# **Development Services**

# APPEAL SUMMARY

Project Address: 1728 NE 45th Ave
Appellant Name: Shem Harding
<b>Appellant Phone:</b> (503) 239-1987 x210
Plans Examiner/Inspector: Kathy Aulwes
Stories: 3 Occupancy: R-2 Construction Type: VB
Fire Sprinklers: Yes - Type 13R throughout
LUR or Permit Application No.: 17-116074-CO
Proposed use: Apartments

#### APPEAL INFORMATION SHEET

**EXTERIOR ELEVATION - NORTH**

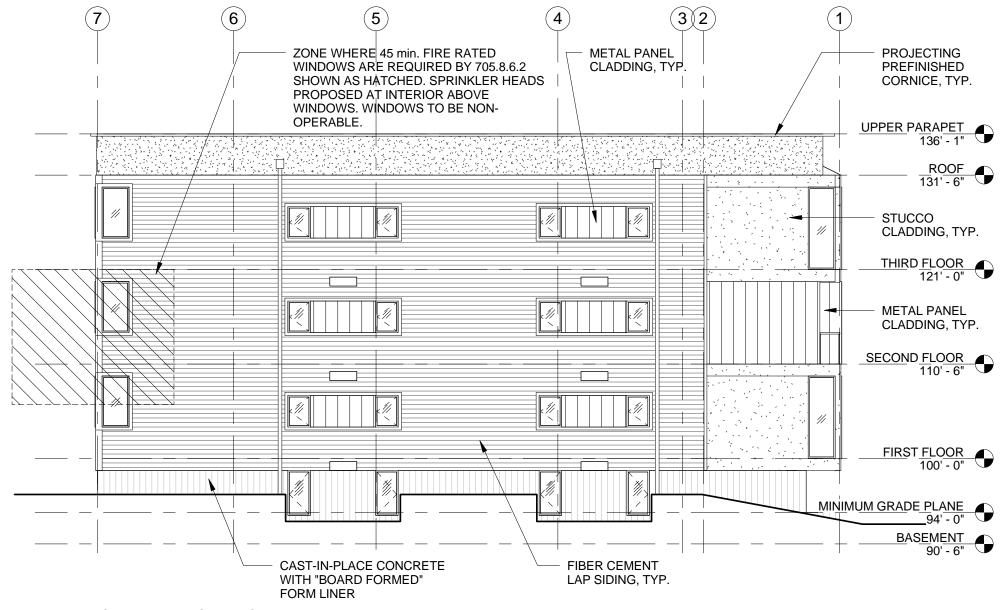
There are two windows on the north elevation of the new building that are subject to this requirement (see attached elevation diagrams). In lieu of providing 45 minute rated windows at these two openings, we propose to install unrated, non-operable windows with quick response sprinkler heads installed above the windows at the interior. The sprinkler heads will be centered on each window and be located between 6" and 24" away from the window surface.

The building will be equipped with a Type 13R sprinkler system as required by code. The sprinkler heads at the windows will be additional to this system. Note that OSSC 705.8.2 already permits sprinkler water curtains in lieu of rated windows for Type 13 sprinkler systems.

The north exterior wall is 1-hr fire rated as required by 602, and is clad with noncombustible cladding materials (stucco, fiber cement and metal).

Reason for alternative This design is proposed to avoid the aesthetic and cost impact of fire-rated windows at the north elevation. Washing a window with sprinkler heads in lieu of fire rated glazing has been approved in the past, and we believe the additional sprinkler heads will provide life safety and fire protection equivalent to the 45 minute fire rated window required by code.

Sprinkler protection at openings in buildings with vertical exposure on separate lots: Granted provided windows are non-operable and sprinklers are installed a minimum of 4 inches and a maximum of 24 inches from the opening(s) spaced at 6 feet on center. Sprinklers are to be installed on the occupied side of the openings and shall be capable of wetting the entire surface. A separate permit from the Fire Marshal's Office is required.
